COMPONENT CODEA1PARTS & SERVICEREF NO.AT04816DATEMay 31, 2004(C)Page 1 of 4

- SUBJECT: IMPROVED TURBO CHARGER COVER ON HD465/605-7 (SAA6D170 ENGINE)
- **PURPOSE:** To introduce modification procedure to improve the heat shielding cover for the turbocharger on HD465-7 and HD605-7 dump trucks
- APPLICATION: HD465-7 Dump Trucks, Serial Nos. up to 7251 (Engine Serial Nos. up to 311487) HD605-7 Dump Trucks, Serial Nos. up to 7114 (Engine Serial Nos. up to 31148⁽)

Fig. 1

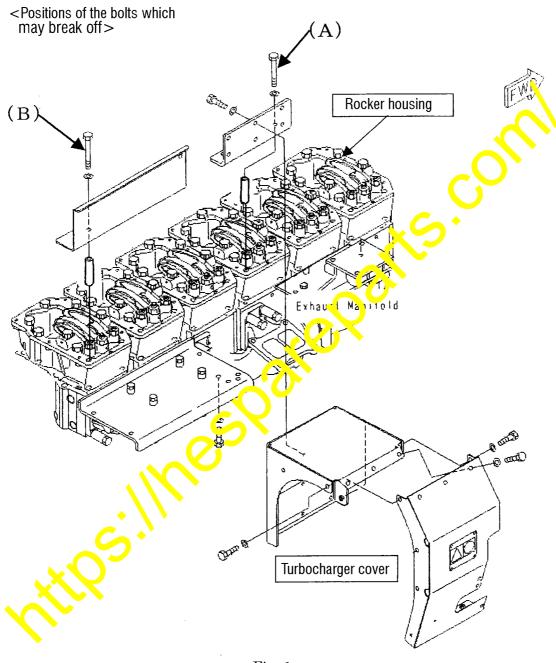
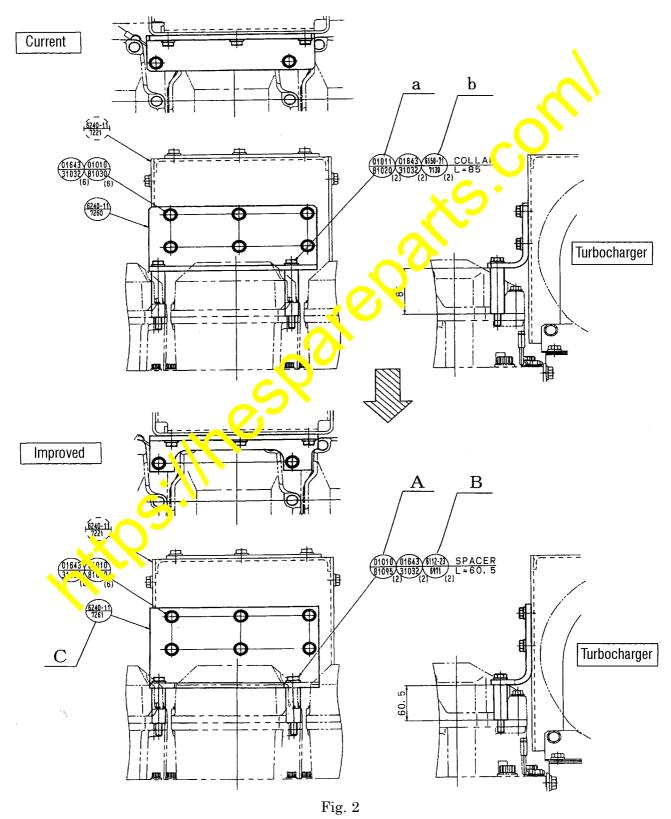
- 3. Details of the modification
- Reason for making this modification To prevent the breakages of the bolts by improving the vibration resistance of the turbocharger cover mounting bolt (A) and the exhaust connector cover mounting bolt (B).

(A) Turbocharger cover: The length of the mounting bolt for the cover is changed from "a" (120 mm) to "A" (95 mm) and the thickness of the spacer is changed from "b" (85 mm) to "B" (60.5 mm).

- 1. When a broken bolt remains in the mounting bolt holes for the rocker housing (6240-11-7110), remove it using a drill, etc.
- 2. Fix the bracket (C) using the bolt (A) and spacer (B).

Fig. 3

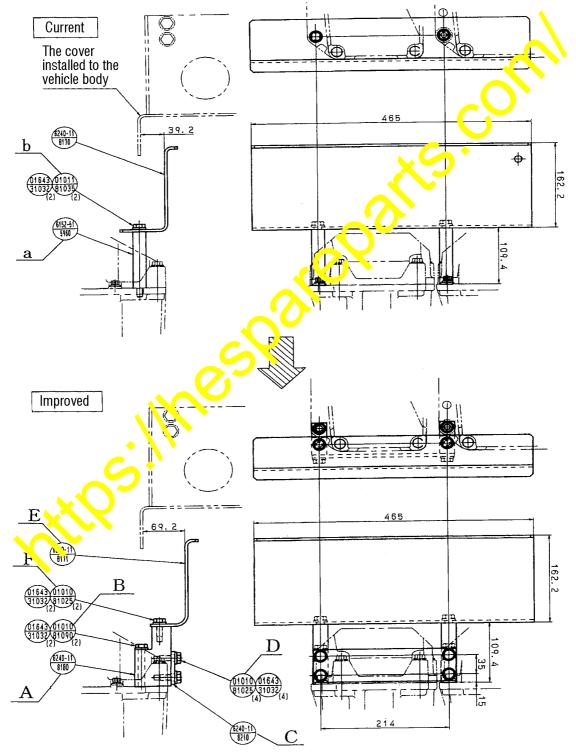
(B) Exhaust pipe connector cover section: The cover mounting spacer (a) is changed to the block type (A) and the length of the mounting bolt is changed from "b" (135 mm) to "B" (90 mm).

- 1. When a broken bolt remains in the mounting bolt holes for the rocker housing (6240-11-7110), remove it using a drill, etc.
- 2. Temporarily fix the bracket (A) using the bolt (B) and fix the plate (C) using the bolt (D). After that, make proper positioning.
- 3. Tighten the bolt (B) finally, and after that, fix the cover (E) using the bolt (F).
